APPLICATION NO.	FILING DATE	FIRST NAMED INVENTOR	ATTORNEY DOCKET NO.	CONFIRMATION NO.
10/716,925	11/19/2003	Paul Harrison	8204	6428

Office Action Summary	Application No.	Applicant(s)	
	10/716,925	HARRISON, PAUL	
	Examiner	Art Unit	
	Jeanne-Marguerite Goodwin	2841

DETAILED ACTION

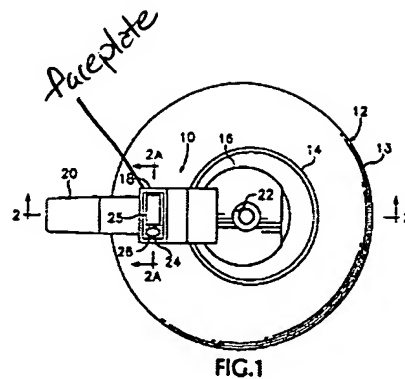
As per claim 23: Furthermore, Johnson's device includes a faceplate (see figure below) for sound housing member, said faceplate inherently having openings in communication with said indicator devices, and said faceplate including markings associated with said indicator devices and the markings providing information related to the freshness state.
